**I-5/SR-78 Interchange Project
Community Working Group Meeting #3**

Meeting Agenda

I-5/SR 78 Interchange Project Community Working Group July 30, 2015

Option 6 – Tunnel Option

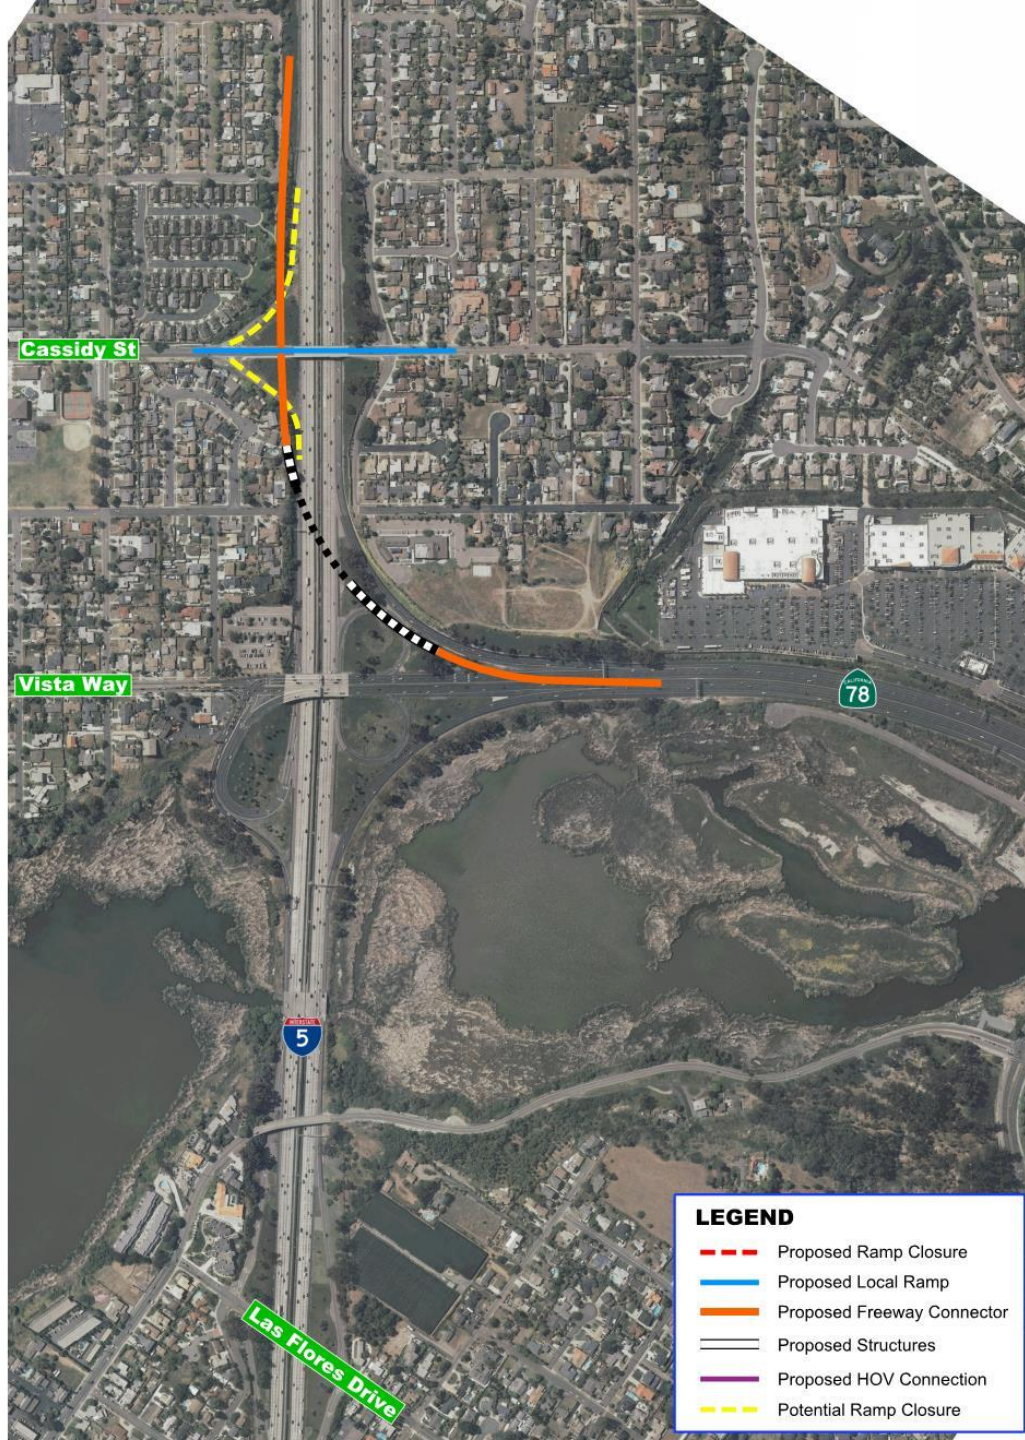
- Removes visual impacts north of interchange
- Does not reduce WB-SB congestion
- No Managed Lanes connectivity
- Exceeds original planning cost estimate
- Continuous maintenance and operation costs
